**From:** [Karen Nielsen](#)  
**To:** [Plan Commission Comments](#)  
**Subject:** 6/10 Mtg: Agenda Item #25  
**Date:** Monday, June 10, 2024 2:58:29 PM

## Comments on Rezoning and Conditional Use for 6610-6706 Old Sauk Road for Plan Commission Meeting June 10, 2024

## Response to Staff Report

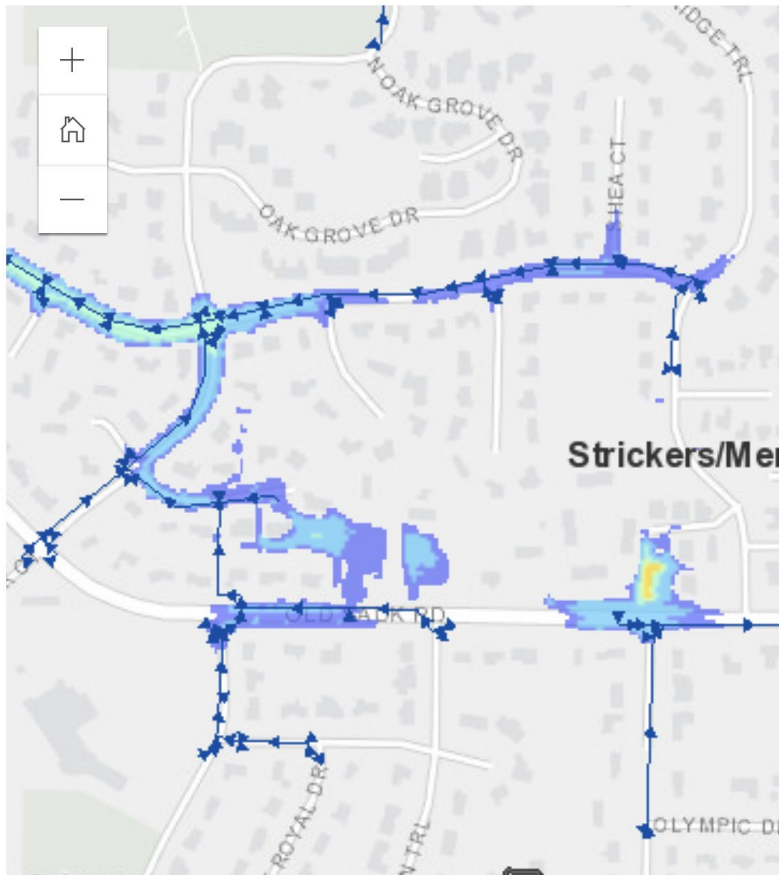
Gregory Fries, P.E., Deputy City Engineer in his letter Stormwater Comments of Old Sauk Road Apartments dated on 5/31/24 and responding to this problem states the following:

From my perspective this design is in serious trouble and will not perform. Soil turning is unproven and not guaranteed to solve the problem. Perhaps the only way to know if it will work is to fully construct the system and then have a water test to prove if required infiltration rates have been met, if not no permit is issued.

“It should be noted that to meet water quality, infiltration, and volume requirements the report notes they plan to “excavate and turn” the soils at the bottom of the infiltration systems. This is proposed to be done to allow the site to reach the design infiltration rates used. I am not aware of standards for turning soils. Additional details/information will be required on how this will be completed and how it will be verified in the field that these infiltration rates have been met. Madison General Ordinance 37 provides for a requirement to certify that the stormwater management plan has been constructed in accord with the design. This provision is not often required but it would be mandated in this case. However, again it is noted that there will be additional information required on how they plan to verify that design infiltration rates proposed are met in the field and a post construction certification will be required as allowed by MGO 37.”
